City of North Miami Beach, Florida

PLANNING AND ZONING BOARD

File No: 21-10

Application Name: NMB Place

Figure MU/TC-9.

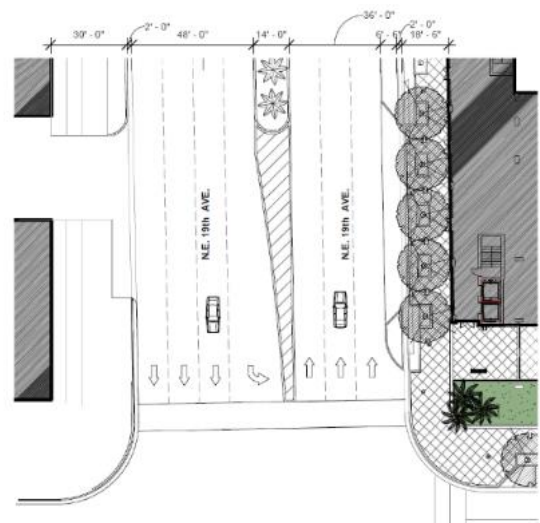
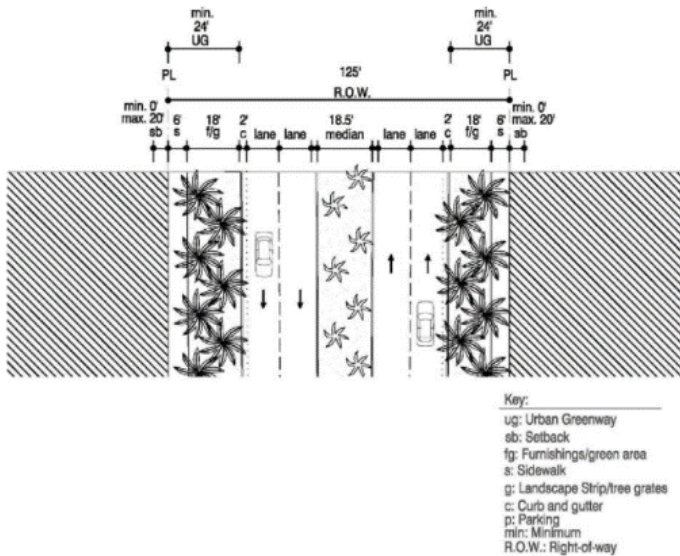
Variance #4: A non-use variance from Section 24-58.1(l)(1)(b.) Figure MU/TC-9 Section to permit a furnishings/green area with a width of 12'-6", where the code requires an eighteen (18) foot width along the NE 19th Avenue greenway.

The requested variance will allow a furnishings/greenway with a reduced width of 12'-6" along the NE 19th Avenue greenway. The applicant contends that due to existing conditions the required width of 18'-0" cannot be provided in the public right-of-way. Appropriate conditions have been prescribed, and staff finds that the request complies with variance review standards.
